# USE ON REVIEW REPORT

► **FILE #:** 2-E-20-UR

► **PROPOSED USE:** **Cherokee Farm Master Plan and Development Guidelines Amendments**

**2-E-20-UR  
USE ON REVIEW**

### 2.1.2 Building Heights

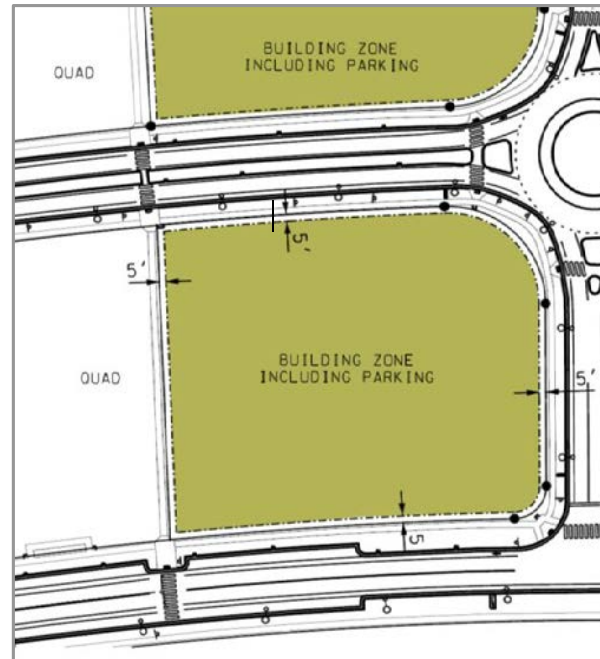
- 2.1.2 Building Heights: We agree and adopt your proposed text of "50'" as opposed to our verbiage of "49".
- 2.1.3 Section Diagram: We agree with your comments and will move the Section Line as he has shown your comments.

Section Diagram

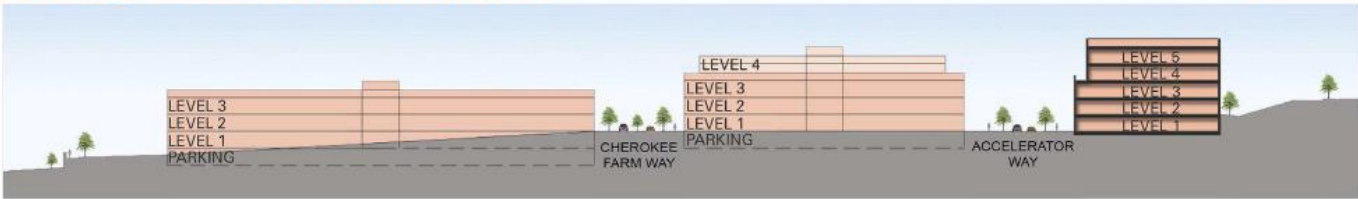
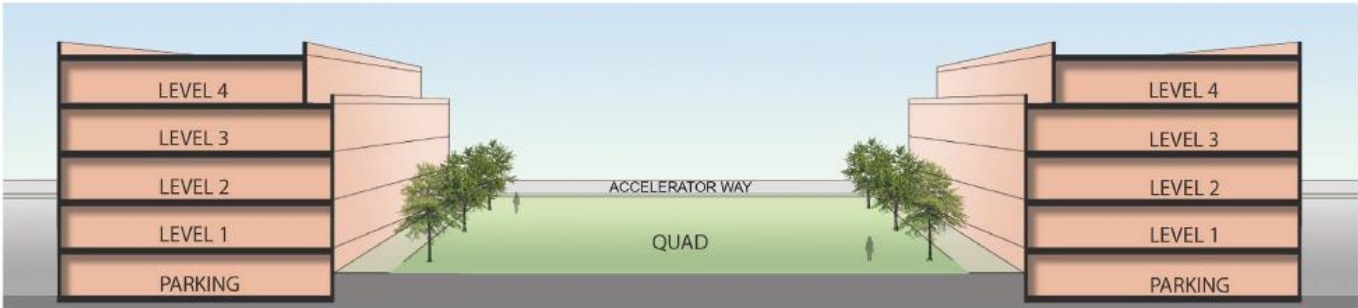
- Regarding the Proposed revised 2.1.3 diagram on Page 9, we are going to revert back to the diagram that is currently part of the approved Master Plan with the exception that the reference to the "vegetated swales" are going to be removed. This should address your concerns about the orientation of the building zone to the quads and the parking areas to the right-of-way.

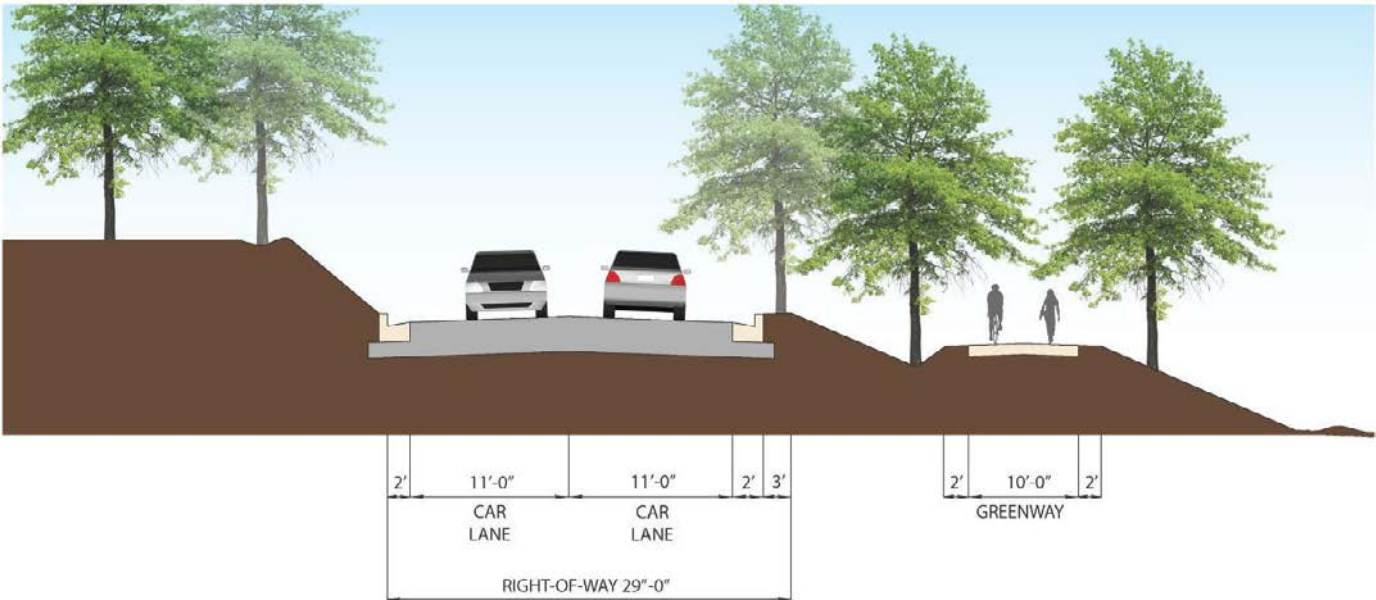
- Stormwater management elements such as ~~vegetated swales~~, tree planting, and rain harvesting features should be integrated into the campus and building site design.
- Stormwater management, grading design and planting selection and location should be fully coordinated to slow

- Plantings should be supported, to the greatest extent possible, ~~by vegetated swales, and~~ through drought resistant and native planting principles. Supplemental irrigation should be confined to building entry areas.
- To minimize erosion, planting designs should be fully coordinated with the grading of walkways, parking lots/islands, lawns, pedestrian plazas/terraces and streets.
- Fine surface grading in the archaeological site should slow and reduce sheet flows. Groupings of trees should be planted to further reduce run-off.
